## **Boggabri Coal Mine Modification 8 Amendment**

### **Updated Surface Water Assessment**

17 November 2022

Appendix A: Response to Comments

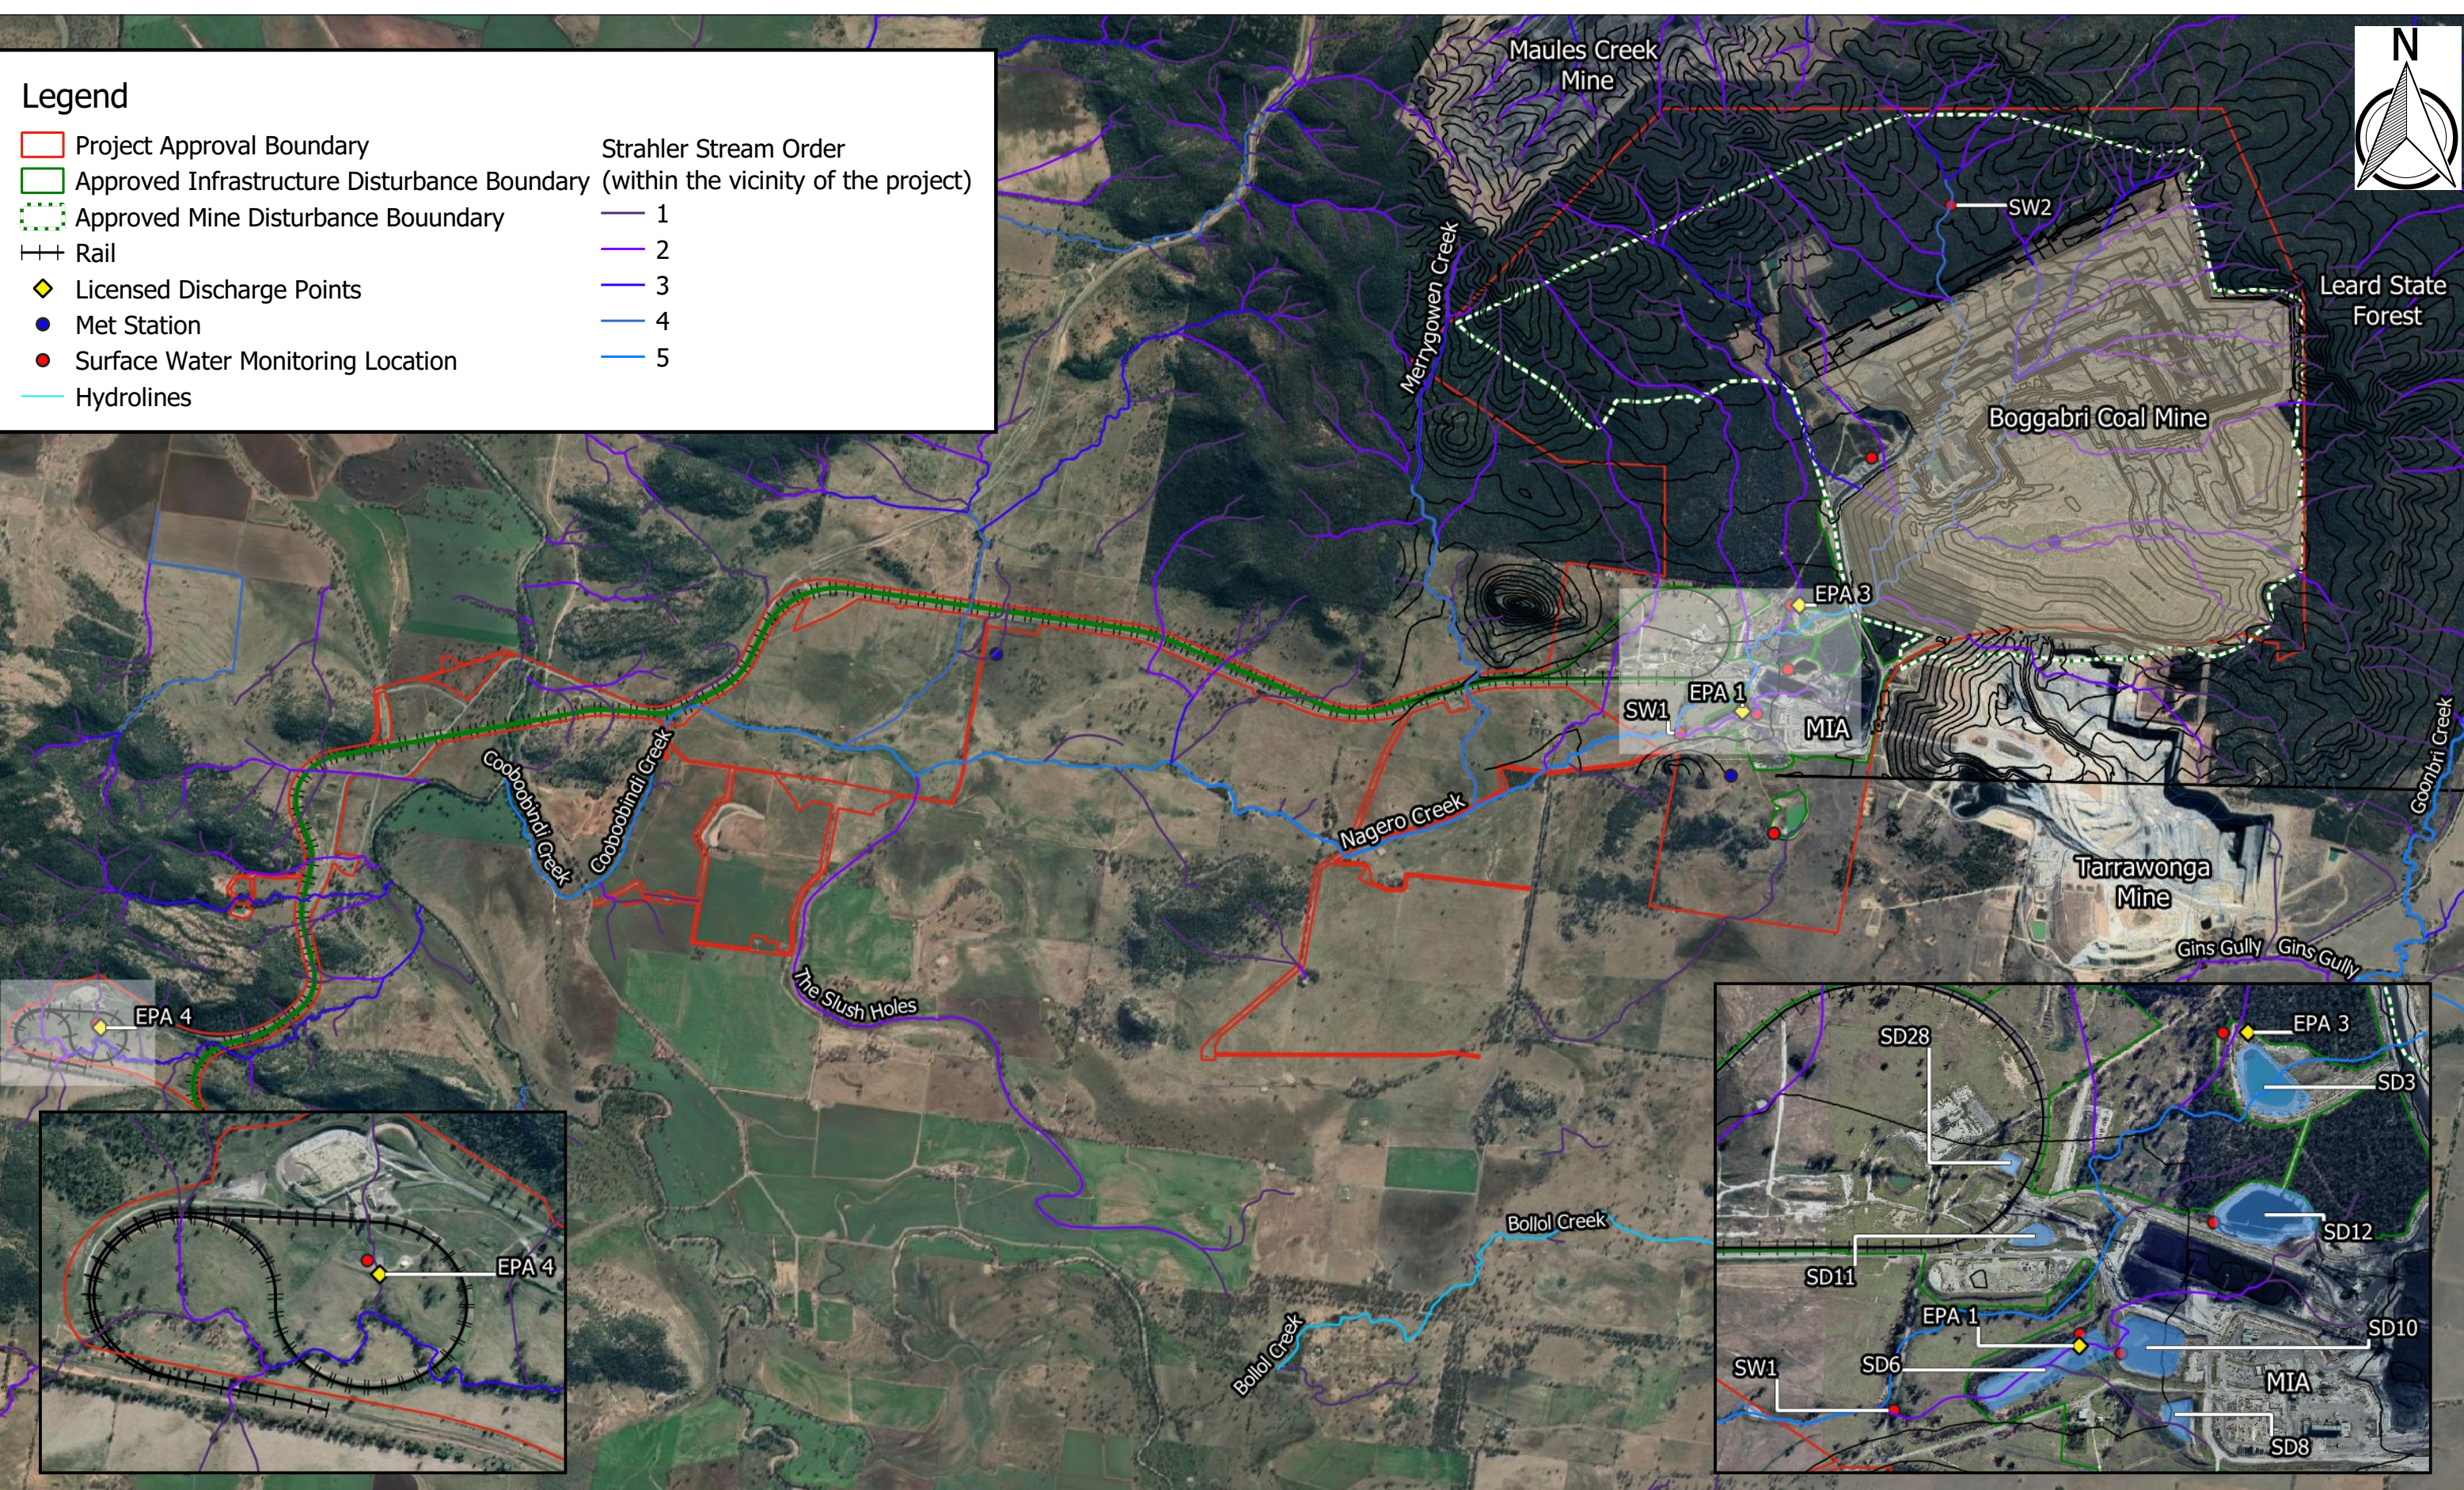
| Comment                                                                                                                                                                                                                                                                                                                                                                                                                                                                                                                                                                                                                                                                                         | Response                                                                                                                                                                                                                                                                                                   |
|-------------------------------------------------------------------------------------------------------------------------------------------------------------------------------------------------------------------------------------------------------------------------------------------------------------------------------------------------------------------------------------------------------------------------------------------------------------------------------------------------------------------------------------------------------------------------------------------------------------------------------------------------------------------------------------------------|------------------------------------------------------------------------------------------------------------------------------------------------------------------------------------------------------------------------------------------------------------------------------------------------------------|
| <p>c. The project site has three licensed discharge points, EPL 1, 3 and 4. The map providing the locations of the discharge points is unclear (Engeny 2021, Figure 2.1). Furthermore, there is an EPL 40 located on Figure 2.1, this is not listed in the EPL-12407. The proponent should provide a map which provides a closer view of the discharge locations, description of the discharge locations and where the discharge will be released. The proponent should also provide the quantity of current and historical discharges, including details on the water quality and frequency of discharge occurrences. Furthermore predicted quantities for discharges should be estimated.</p> | <p>Figure 2.1 updated.</p> <ul style="list-style-type: none"> <li>- Overview windows provided for more clarity at each LDP.</li> <li>- LDP 40 removed.</li> </ul> <p>Historical discharges addressed in Section 2.3.2.</p> <p>Predicted discharges addressed in Section 4.2 (Table 4.2 and Figure 4.2)</p> |
